**STAFF RECOMMENDATION**  
**1109 Porter Road**  
**July 21, 2021**

**Application:** Demolition; New Construction—Infill and Outbuilding  
**District:** Eastwood Neighborhood Conservation Zoning Overlay  
**Council District:** 06  
**Base Zoning:** R6  
**Map and Parcel Number:** 08303016500  
**Applicant:** Brent Hunter  
**Project Lead:** Melissa Sajid, [Melissa.sajid@nashville.gov](mailto:Melissa.sajid@nashville.gov)

Figure 5. Proposed front elevation.

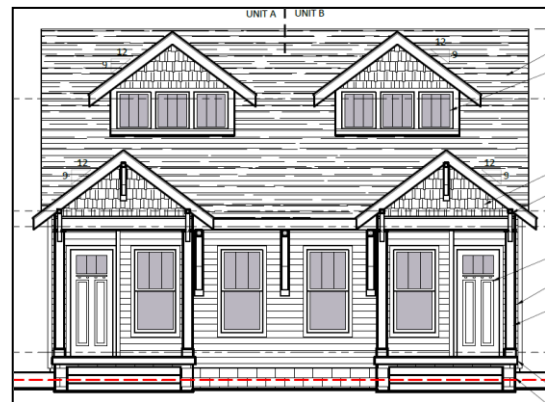
The proposed infill for 1109 Porter Road is twenty-five feet (25') tall and thirty-four feet (34') wide, which matches the maximum height and width of the historic context (Figures 5-6). The new construction reads as one and one-half stories at the front, but the two-story scale on the side elevations combined with the width of the front dormers as well as the overall height and width push the overall scale to a large one and one-half story infill that is inappropriate for the historic context. The front dormers are each approximately nine feet (9') wide and accommodate triple windows; front dormers on historic homes on this block are smaller and typically accommodate a paired window. The proposed side elevations are a full two-stories with approximately nineteen-foot (19') eaves for the majority of the depth.

While a one and one-half story infill would be appropriate for this lot, staff finds that the height and scale of the proposed infill overwhelm the historic context. Since a revised plan addressing staff’s concerns over the height and scale would likely result in a redesign of the project, staff recommends disapproval since the proposed infill does not meet Sections V.A and V.B. of the design guidelines.

Staff recommends disapproval of the proposed infill and outbuilding, finding that the project does not meet Sections V.A (Massing and Scale) and V.B (Form) of Part I of the consolidated design guidelines for the turn-of-the-century neighborhood conservation zoning overlays.

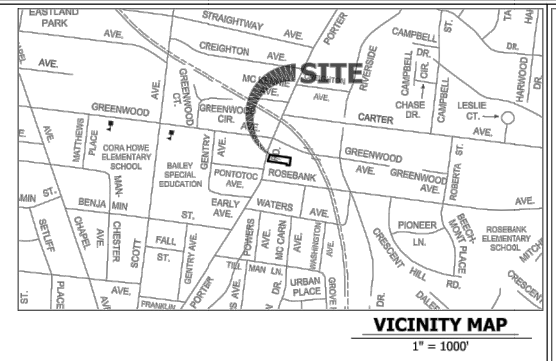
The proposed outbuilding does not incorporate any add-on features. Staff finds that the outbuilding's siting and setbacks to meet Section VII.D. of the of Part I and the Eastwood chapter of Part II. of the consolidated design guidelines for the turn-of-the-century neighborhood conservation zoning overlays.

Although the outbuilding meets the design guidelines, it is not known how it will compare to a revised infill design, if the current proposal is disapproved. In addition, Codes will not allow for the construction of an outbuilding without a primary building. For those reasons, staff recommends disapproval of the outbuilding as well.
